# CHANGE ORDER

Project Name: **Stoughton Fire Station No. 1** CO No. **05r**  
400 Prospect Street

Architect's Project No. **19-0796**

## Change Order No. 05

**Level 2 Framing Plan**  
 -TOS El.: 13'-7 1/2" (I.r.n.o.)  
 - On Plan Indicate Field Welded Moment Con. (See Typical Details)  
 - On Plan Indicate Field Welded HSS to HSS Con. (See Detail 5/E1007)

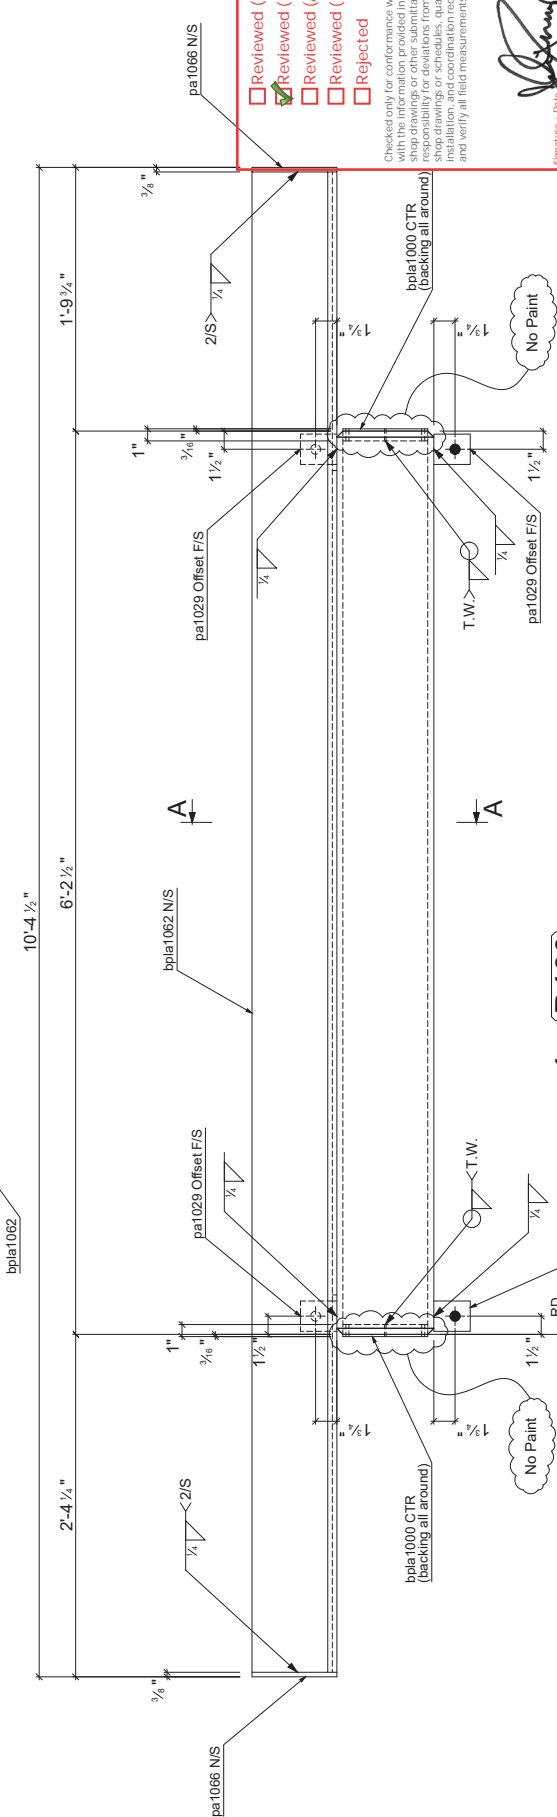
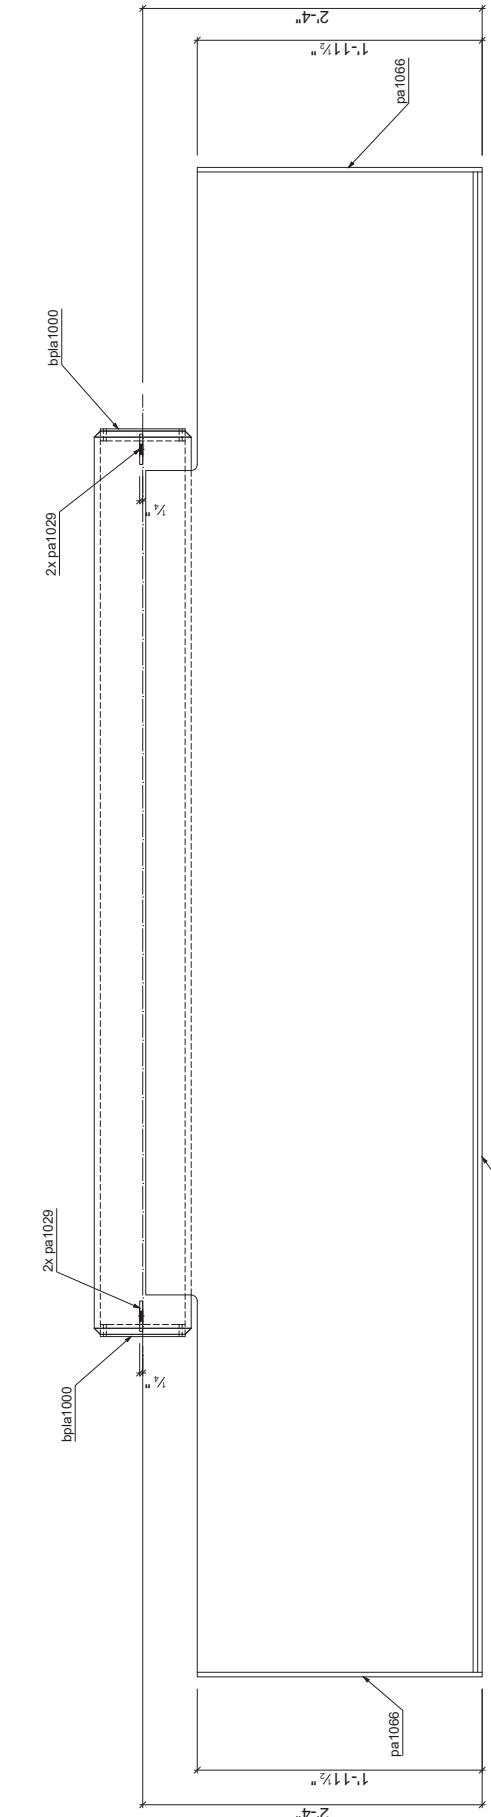
During the review of the shop drawings, galvanised stiffener have been added at the canopy and additional beams have also been added.

EDM M. MASFUKAH  
 2023-06-22  
 PROVIDE GALVANIZED STIFFENER PLATE AT THE EDGE  
 OF THE CANOPY TO SUPPORT THE SLAB EXTENSION.

Project: **Stoughton Fire Station**  
 Grid Ref.: (8/F 2)/(7/F 2)  
 Paint: Grey (u.n.o.)  
 Role: Beam  
 Holes: 13x16x0 in | E70XXELECT HSS 8x8x1/2  
 Weld: #19-0796  
 Drawn by: SDD  
 Verify by: SDD Check  
 Contract #: C2023-004  
 Sheet: **B108**

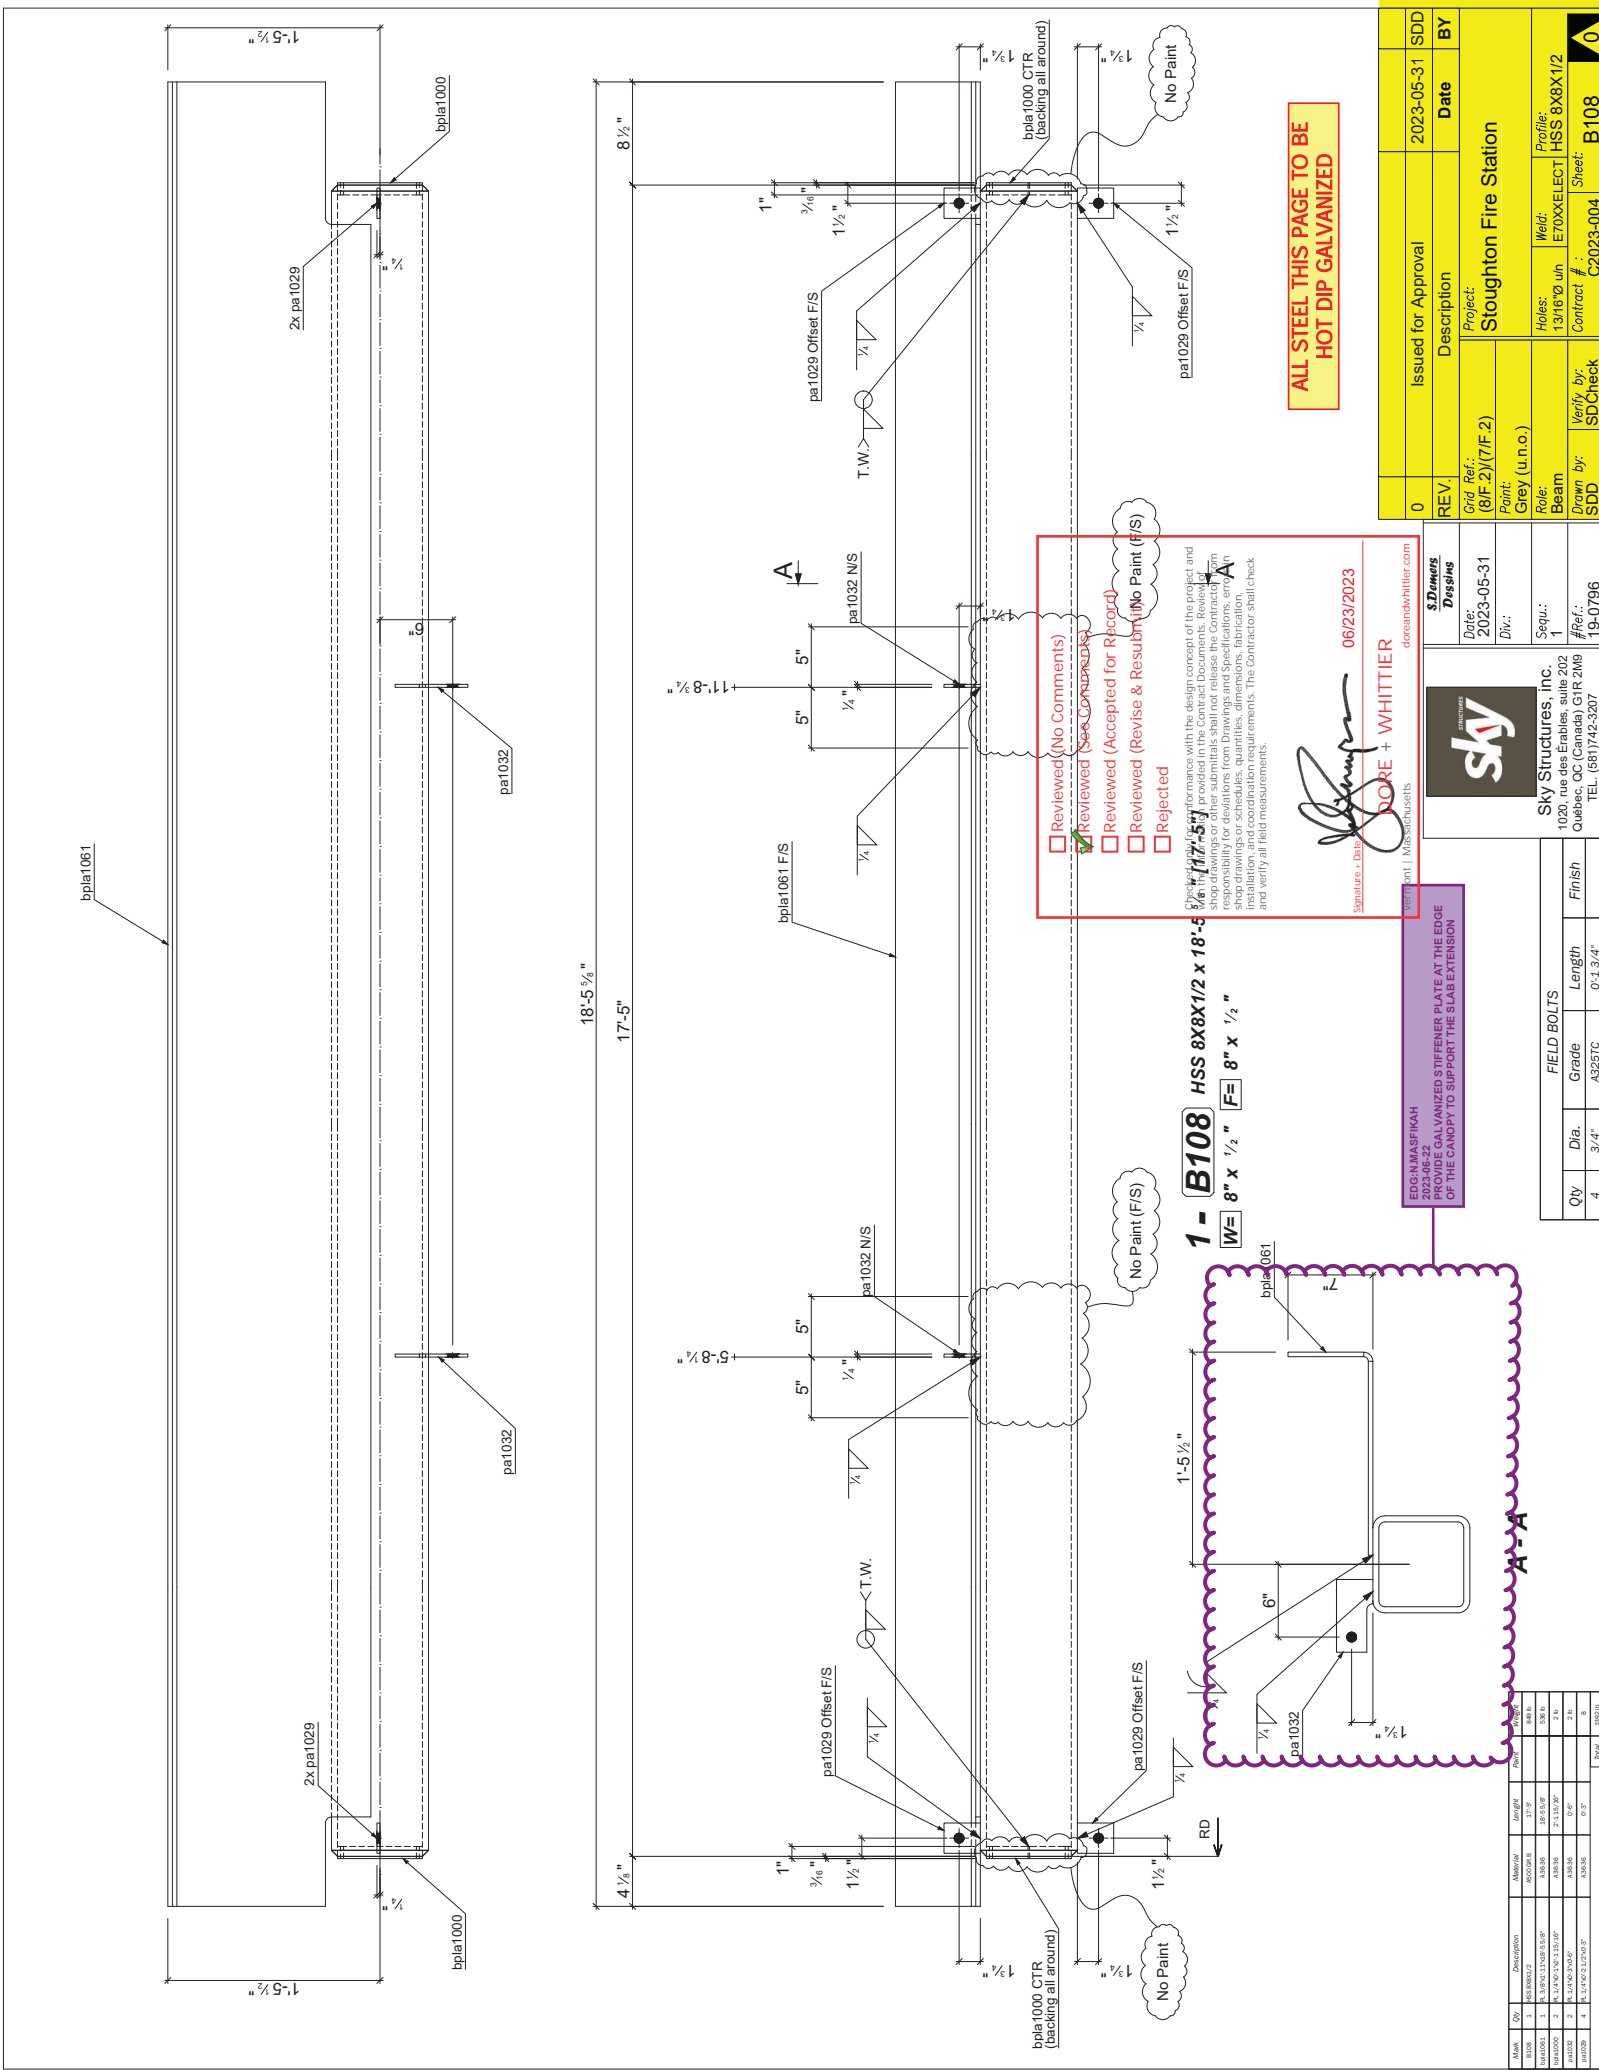
**ALL STEEL THIS PAGE TO BE HOT DIP GALVANIZED**

S. Demers Designs	
Date:	2023-05-31
Grid Ref.:	(9.1/F.2)/(8/F.2)
Div.:	
Paint:	Grey (u.o.o.)
Role:	Beam
Holes:	13x16 @ 4 in
Weld:	E70XXELECT
Profile:	HSS 8X8X1/2
Contract #:	C2023-004
Sheet:	B109
Verify by:	SDCheck
#Ref.:	19-0796

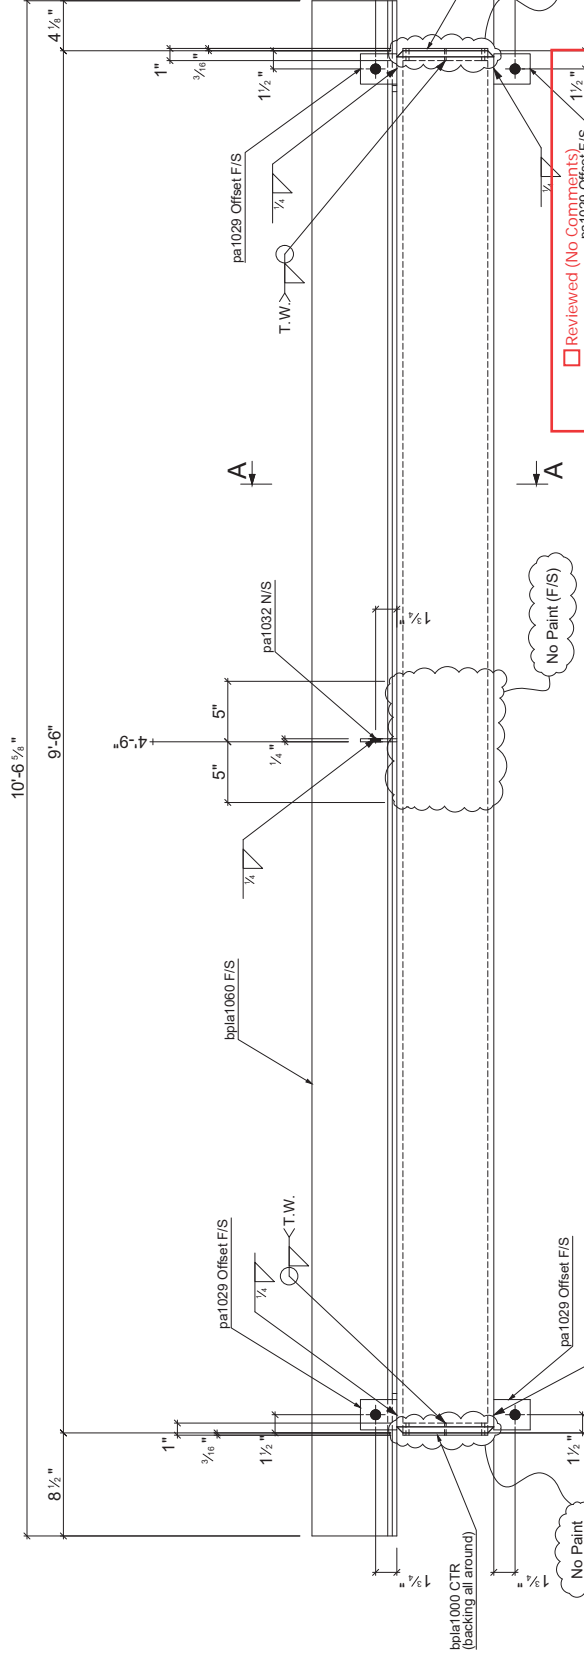
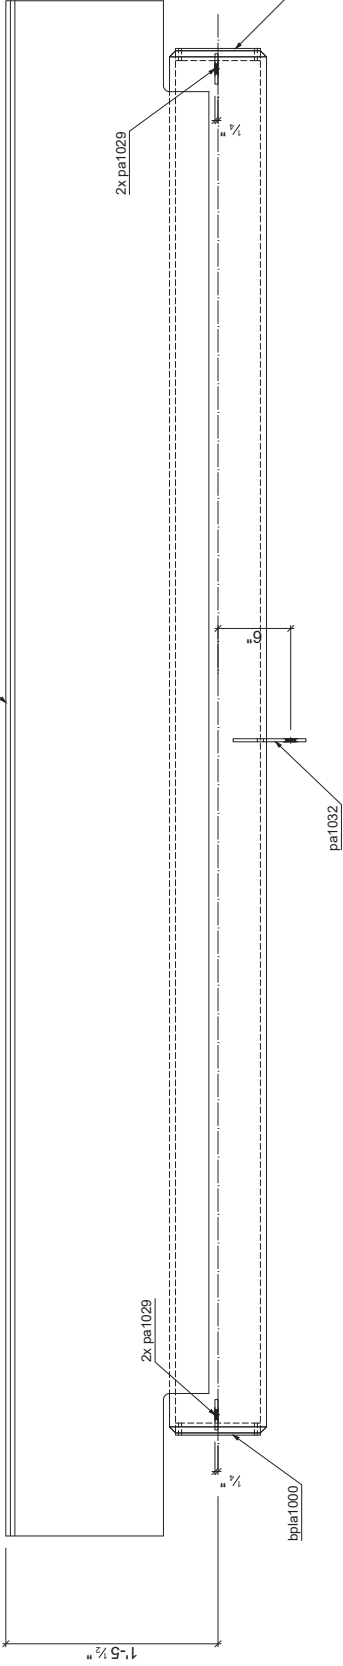
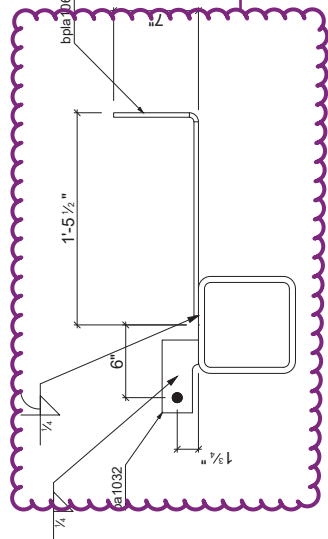
ERIN MARSKAK  
 2023-05-22  
 PROVIDE GALVANIZED STIFFENER PLATE AT THE EDGE OF THE CANOPY TO SUPPORT THE SLAB EXTENSION

Project: **Stoughton Fire Station**  
 Grid Ref: (8/G)/(7/G)  
 Point: Grey (u.n.o.)  
 Role: Beam  
 Drawn by: SDD  
 Verify by: SDCheck  
 Contract #: C2023-004  
 Sheet: B110

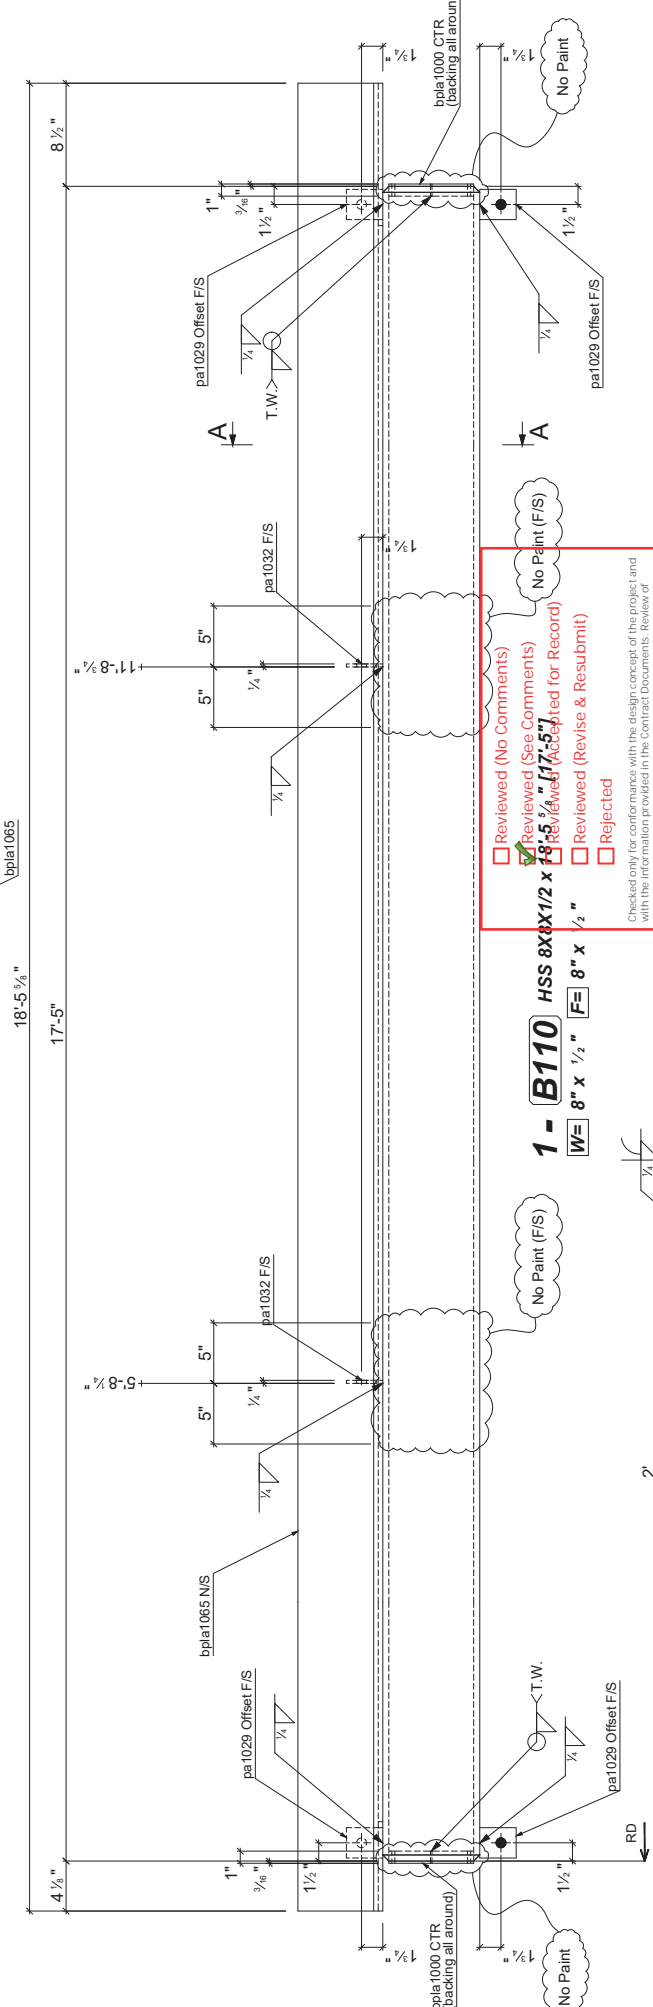
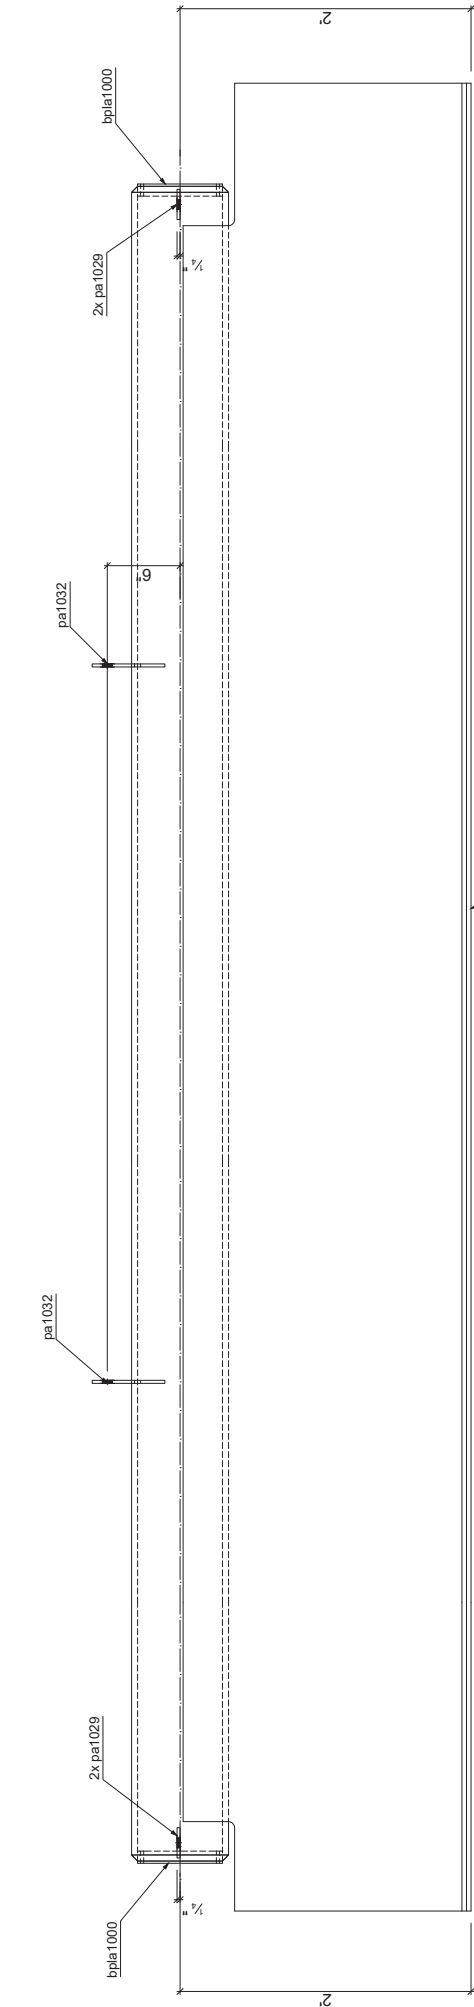
EDGE-N. MASPIRAH  
 PROVIDE GALVANIZED STIFFENER PLATE AT THE EDGE  
 OF THE CANOPY TO SUPPORT THE SLAB EXTENSION
